Project	IEEE 802.16 Broadband Wireless Access Working Group < http://ieee802.org/16 >	
Title	Entering the community using coexistence proxy	
Date Submitted	2006-02-28	
Source(s)	Phillip Barber, Wu Xuyong, Pan Zhong, Zhao Quanbo, Huawei Huawei Industrial Base, Bantian, Longgang, Shenzhen 518129 P.R.C	Voice: +86-755-28971677 Fax: +86-755-28975523 PBarber@BroadBandMobileTech.com wuxuyong@huawei.com
Re:	80216h-06_005: Call for Comments and Contributions: IEEE 802.16 License-Exempt Task Group (2006-02-06)	
Abstract	Broadcasting the IP address of BS is putting the BS into risk of being attacked from the internet, to use coexistence proxy between BSs in coexistence negotiation and cooperation could be a way out.	
Purpose	To consider a acceptable way of delivery the contact information between BSs in a community.	
Notice	This document has been prepared to assist IEEE 802.16. It is offered as a basis for discussion and is not binding on the contributing individual(s) or organization(s). The material in this document is subject to change in form and content after further study. The contributor(s) reserve(s) the right to add, amend or withdraw material contained herein.

Entering the communit

Figure hxx. IBS entering the community by neighbor update request broadcasting

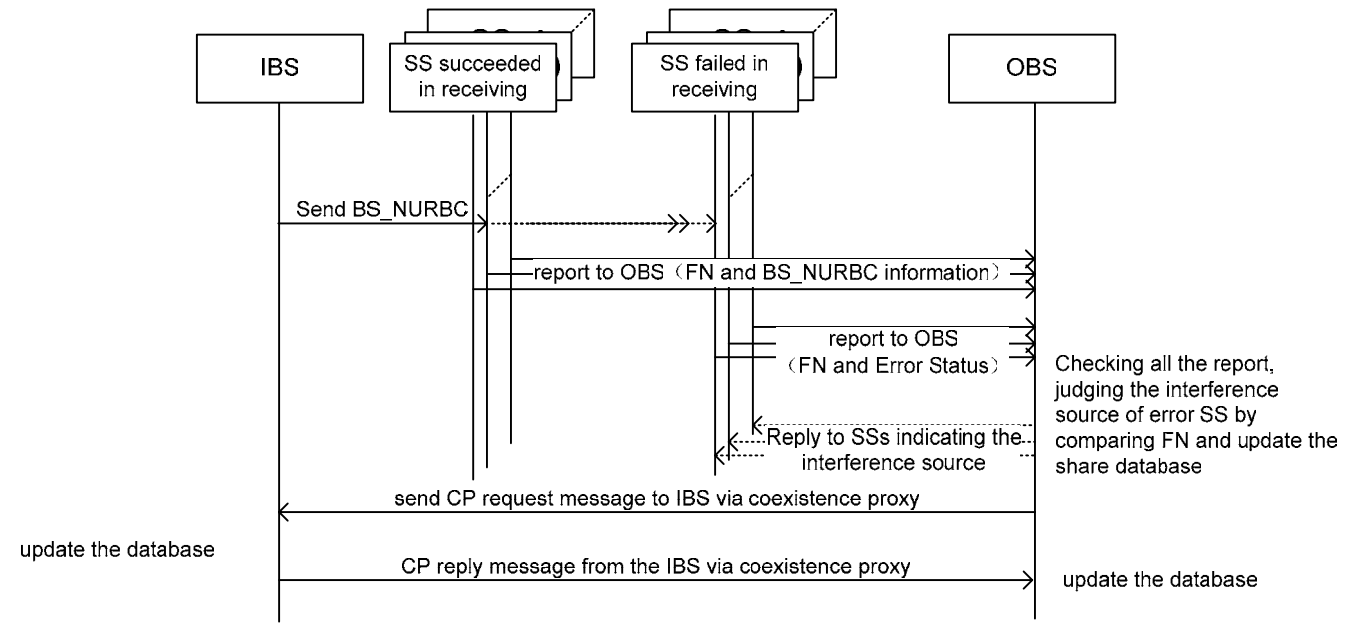
The BS_NURBC (see 15.6.6.2.1) broadcasting procedure is unidirectional, only from the BS to the SSs in common coverage of the BS and its neighbors', and the SSs shall report all the useful information to their OBSs they associated to. The SSs that succeed in receiving the message should report the content of BS_NURBC and the frame number of the starting frame of BS_NURBC, the SSs failed to received the broadcasting message but got BS_NURBC like interference in the CTS should report the error status and the starting frame number of receiving the interference in CTS. IBS use ICTS to broadcast BS_NURBC message, the content in the message will enable its neighbor systems to communicate with the IBS in the IP network to coordinate by coexistence protocol. By the IP address of IBS's coexistence proxy and the BSID reported from the SSs with RTK, the OBSs will then communicate with the IBS in the IP network via their coexistence proxy, and go further coordinate using IP network. And by checking the frame number in the report, OBS need to find out if the SSs that report the error status in BS_NURBC receiving have got the same interference source, then OBS will update the database and reply to the SSs which have send the error report.(see figure hxx.)
